UNITED STATES PATENT AND TRADEMARK OFFICE

| APPLICATION NO. | FILING DATE | FIRST NAMED INVENTOR | ATTORNEY DOCKET NO. | CONFIRMATION NO. |
|-----------------|-------------|----------------------|----------------------|------------------|
| 10/756,877 | 01/13/2004 | Lon Richard Buske | 10331.1/40176.64USC1 | 3429 |

Office Action Summary

FIG. 2

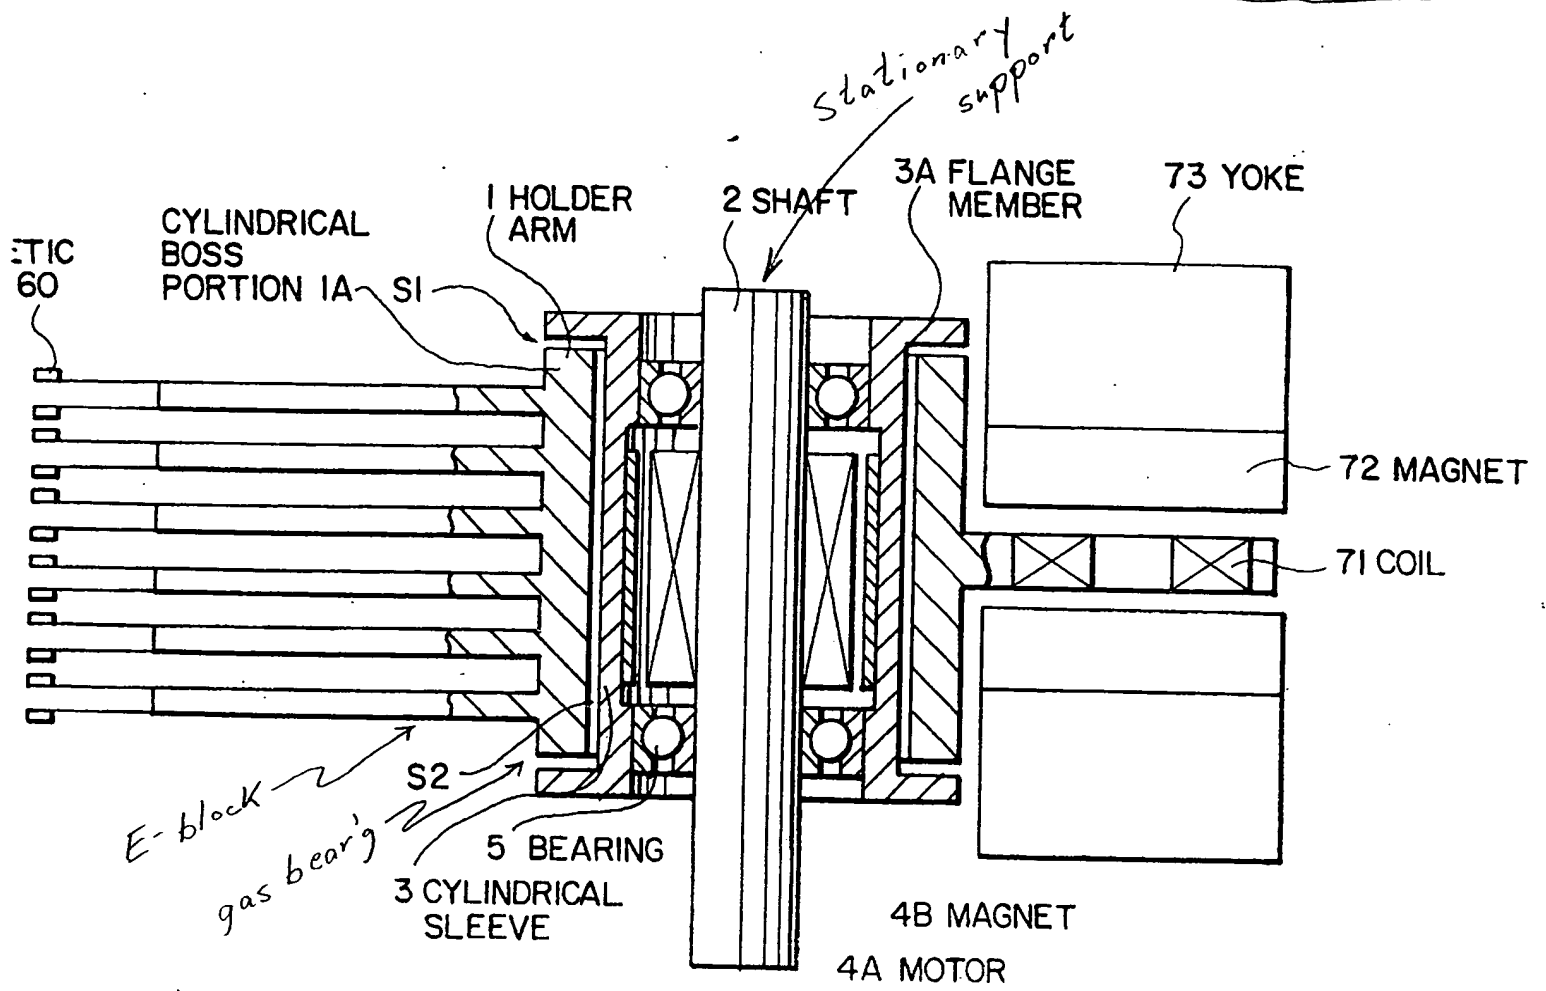
5. Claims 10-12 are rejected under 35 U.S.C. §102(b) as being anticipated by Sanada.

See Fig. 2. Note, to the extent claimed and understood, the structure as shown in Addendum A reads on and performs to the same degree as claimed; e.g. the claimed invention fails to enunciate any structural distinction which is more 'vibrationless' than that shown in Sanada.
